CP-202200006  
TXX-22002  
February 17, 2022

Subject: Comanche Peak Nuclear Power Plant (CPNPP)  
Docket Nos. 50-445 and 50-446  
Second Supplement to License Amendment Request (LAR) 20-006  
APPLICATION TO REVISE TECHNICAL SPECIFICATIONS TO ADOPT RISK INFORMED  
COMPLETION TIMES, TSTF-505, REVISION 2, "PROVIDE RISK-INFORMED EXTENDED  
COMPLETION TIMES - RITSTF INITIATIVE 4b (Accession No. ML21131A233)"

NRC Audit of TSTF-505 License Amendment Request Results Summary and CPNPP Response

Comanche Peak RICT LAR Audit Questions and Response 1 through 28

#### **QUESTION 21 – Potential Electrical Loss of Function (LOF) (EEEB)**

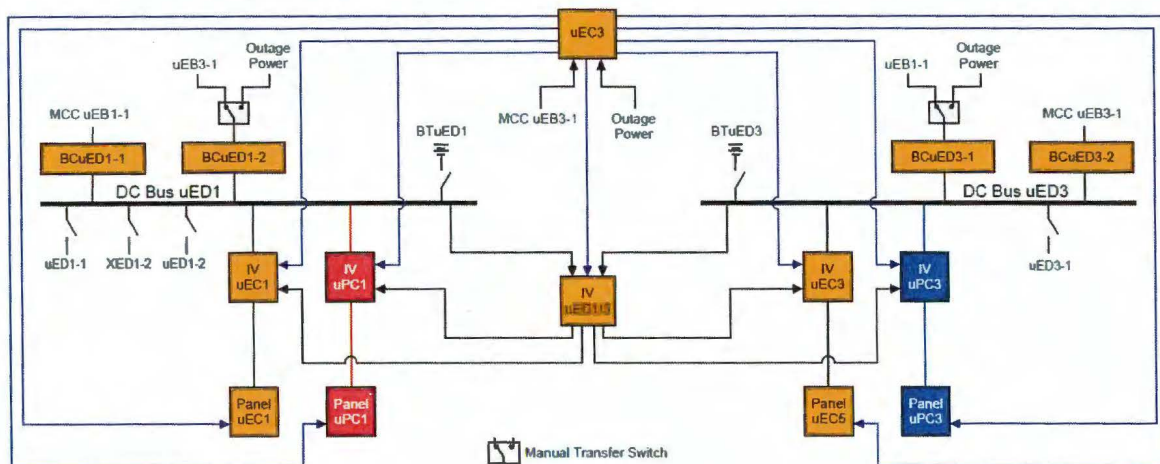
As part of its TSTF-505 review, the NRC staff examines each proposed TS condition for the potential LOF. One method to do that is reviewing the design success criteria (DSC) the licensee provided in the LAR. The DSC is a minimum set of remaining equipment required to perform the safety function. The DSC must demonstrate that the proposed change will not result in a LOF. The staff notes that the following DSC in Table E1-1 of Enclosure 1 of the LAR do not reflect the criteria of DSC and therefore, raise the concern of the potential LOF.

- a) TS 3.8.1 Condition F is "One SI sequencer is inoperable." The DSC in Table E1-1 for this TS condition is "See LCO 3.8.1.B." LCO 3.8.1.B is for "One DG is inoperable." Clarify or correct this DSC information in the Table.

**License Amendment Request docketed change is found in Enclosure 1, Table E1-1, TS 3.8.1, Condition F, that has been revised to clarify that the other train SI sequencer satisfies the DSC.**
